# CITY OF ALBUQUERQUE

RE: **Lot 3 Block 8 Unit 5 SAD 227**  
**6215 Keyenta Pl, NW**  
**Volcano Cliffs Subdivision**  
**Grading and Drainage Plan**  
**Engineers Stamp Date 9/1/2025 (E10D130)**  
**Case #: HYDR-2025-00317**

Based upon the information provided in your submittal received 9/6/2025, this plan is approved for Grading Permit.

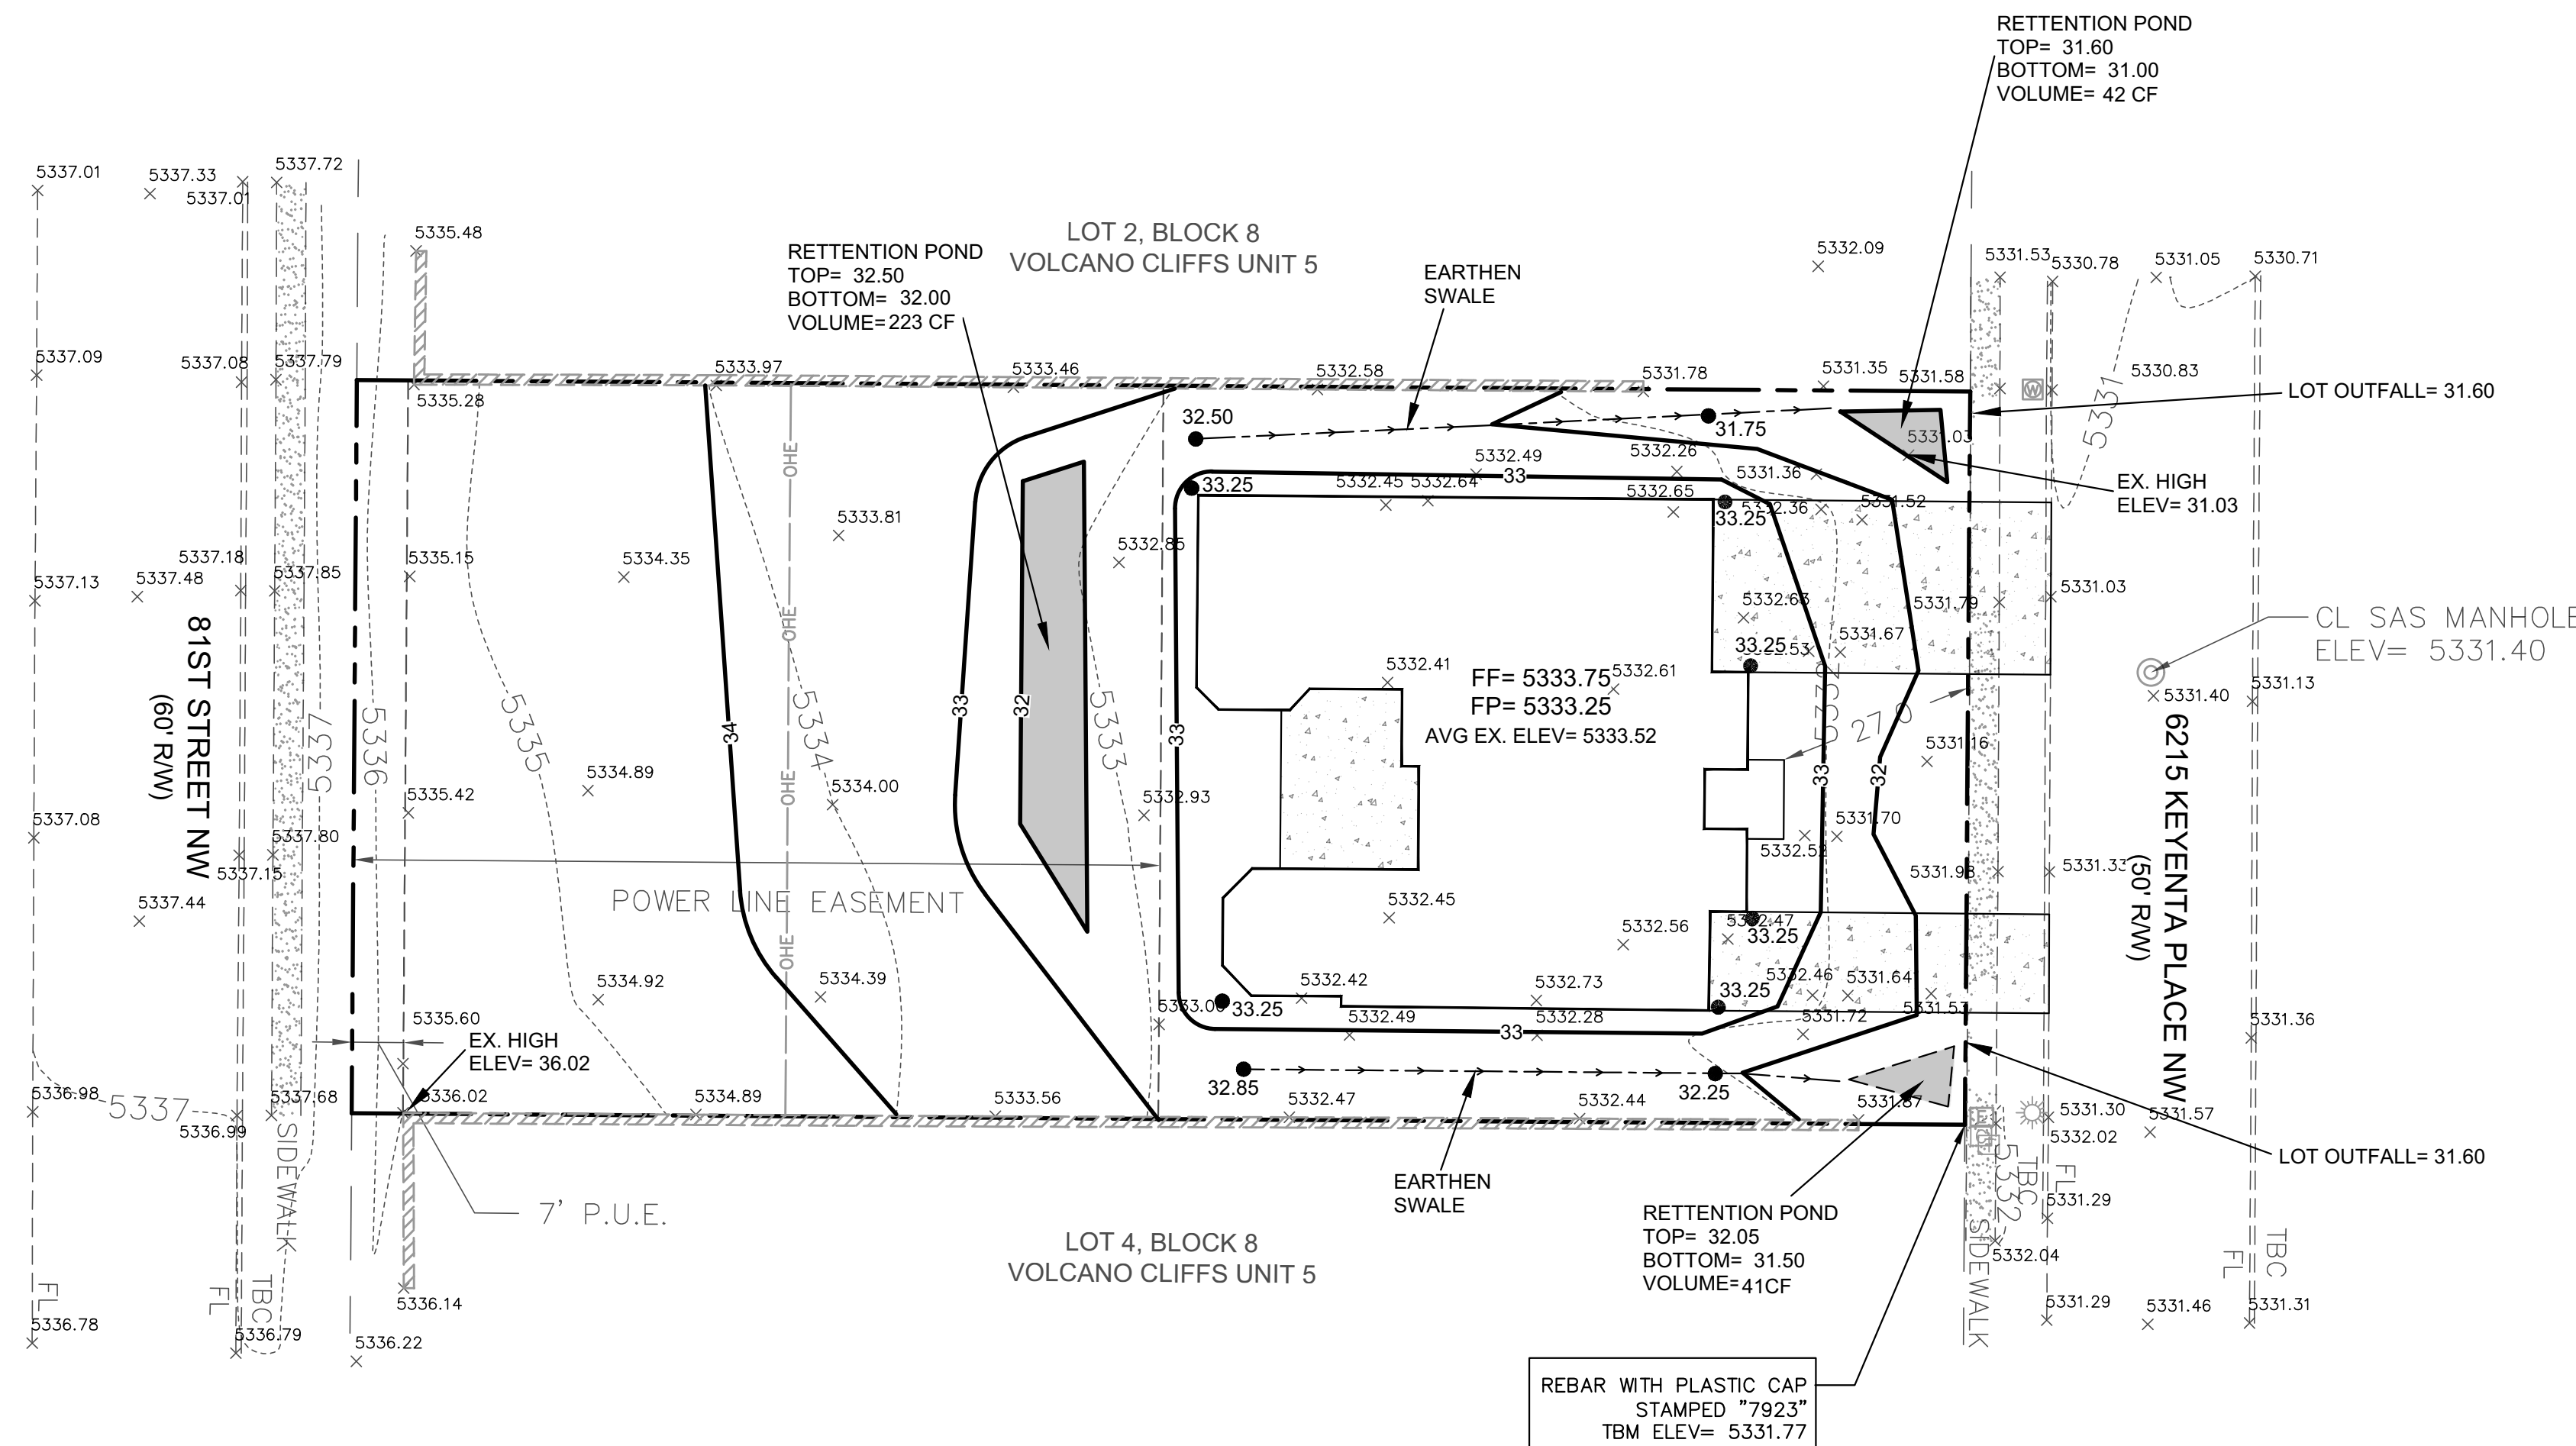
**Prior to Building permit approval a Pad Certification will be required, provided by the Engineer or a registered Land Surveyor.**

**Advise the owner contractor not to use dirt as a ramp to climb the curb, use lumber or crusher fines for this purpose. Place this note on the plan.**

**Reiterate to the Owner/Contractor that a separate permit for a garden/retaining wall must be obtained with the approved G&D plan and Pad Certification. Also, if a swimming pool is to be placed after this approval a new grading and drainage plan will need to be resubmitted showing the changes for the land treatments.**

**Prior to Certificate of Occupancy release, Engineer Certification per the DPM checklist is required.**
